# Product Change Notification

## 107859 - 00

**Change Notification #:** 107859 - 00  
**Change Title:** The Intel PRO/MT Dual Port Server Adapter (Double Barrow), PRO/1000 MF Dual Port Server Adapter (Double Eldridge), PRO/1000 MT Server Adapter (Everson), PRO/1000 MF Server Adapter (Baldry), and PRO/1000 MF Server Adapter LX (Baldry LX) (Retail & OEM Generic Adapters)

**UL Logo Label Addition to the Front of the Printed Board**

**Old UL logo, silk screened onto the printed board.  
Note slight space between the two letters (example only)**

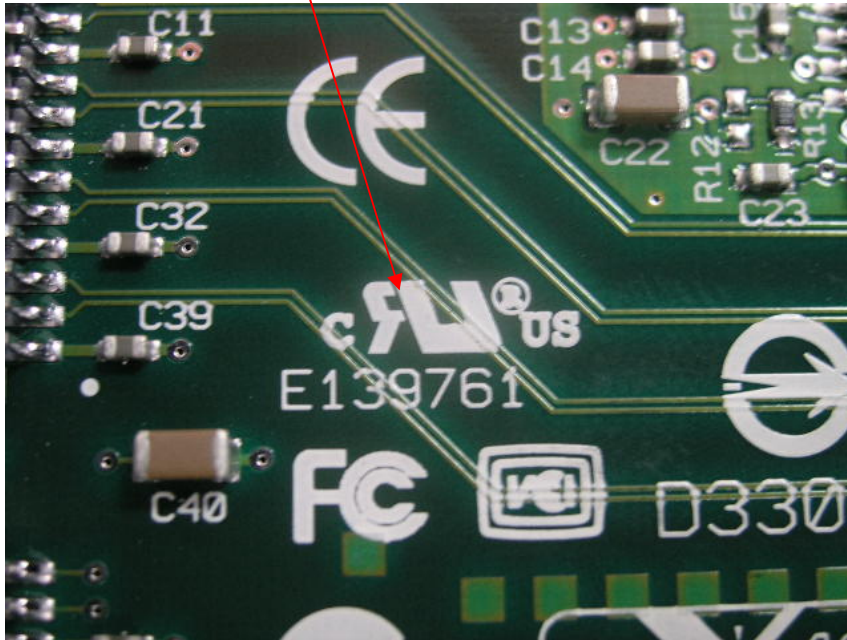
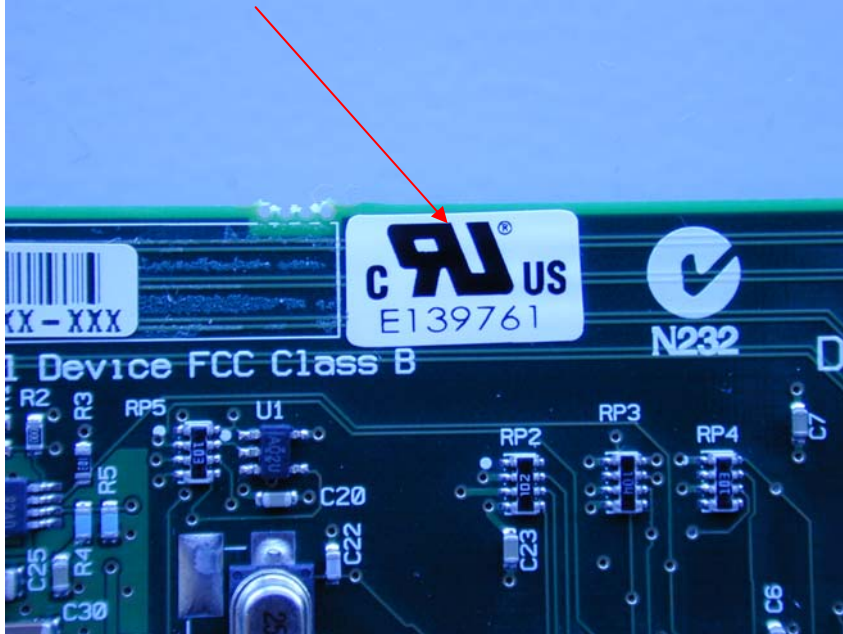
Intel is updating our UL logo which is placed on the primary (front) side of the Printed Board (PB). The slight space between the two letters will be closed. There is no change in our UL Certification. This update logo label will be placed over the previous silk screened label. **See picture of the updated UL Logo label below.**

The previous version of the UL Logo was silk screened on the primary side of the PB, this logo included a space small space between the two letters. **See picture of the previous UL Logo below.**

The New UL logo label, will be placed as a label over the original silk screened marking. Note the space between the two letters is now closed.

Note slight space between the two letters is now closed (example only)
